PRODUCT ADVISORY

Data Sheet Specification Change for Intersil Products ISL8200MMREP and ISL8200MMREP-T

**Refer to:
PA13028**

Date: March 15, 2013

Old Reflow Profile – PA13028

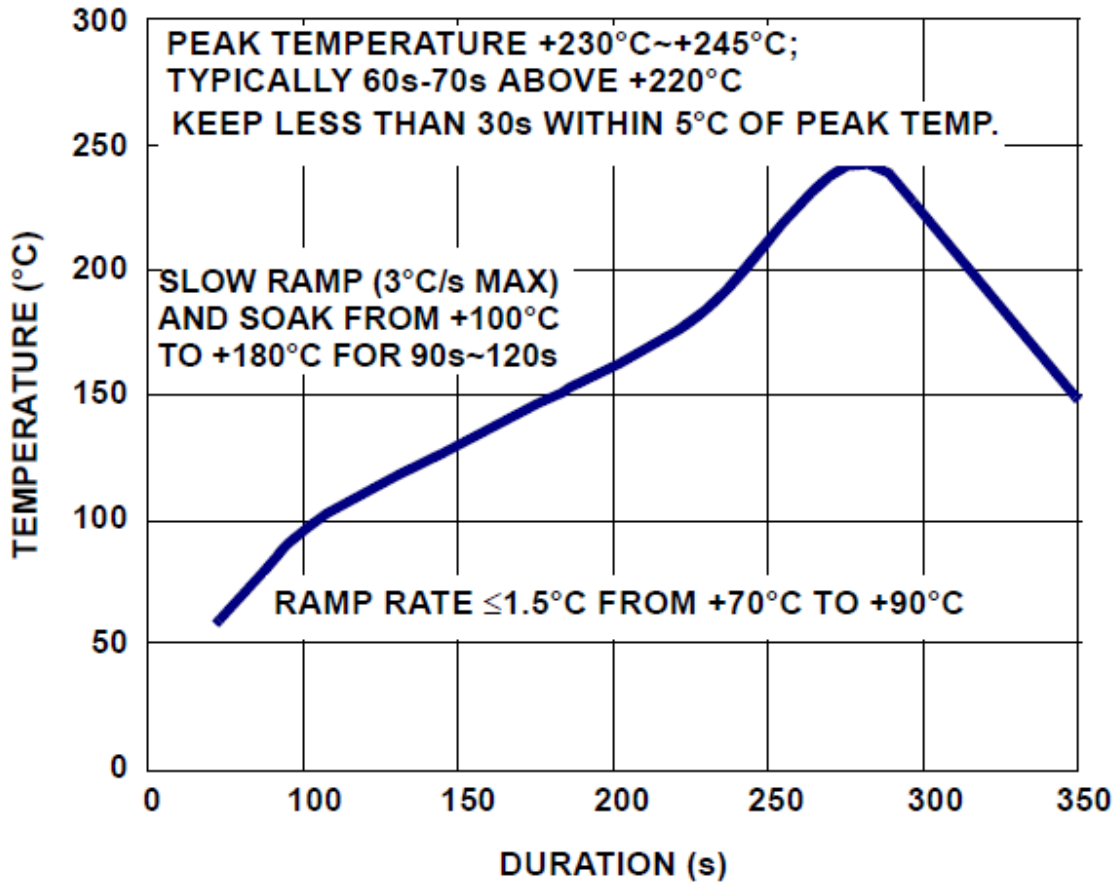
This advisory is to inform you that Intersil has updated the data sheet specification for the ISL8200MMREP and ISL8200MMREP-T products. The update includes changes to the reflow profile only. The changes include differences in the dwell time at peak temperature; peak temperature and the slow ramp soak duration. The old and new reflow profiles are contained on the following pages. There have been no changes to the electrical specifications table in the data sheet. There have been no changes made to the die/silicon or device itself. There will be no change in external marking of the packaged parts.
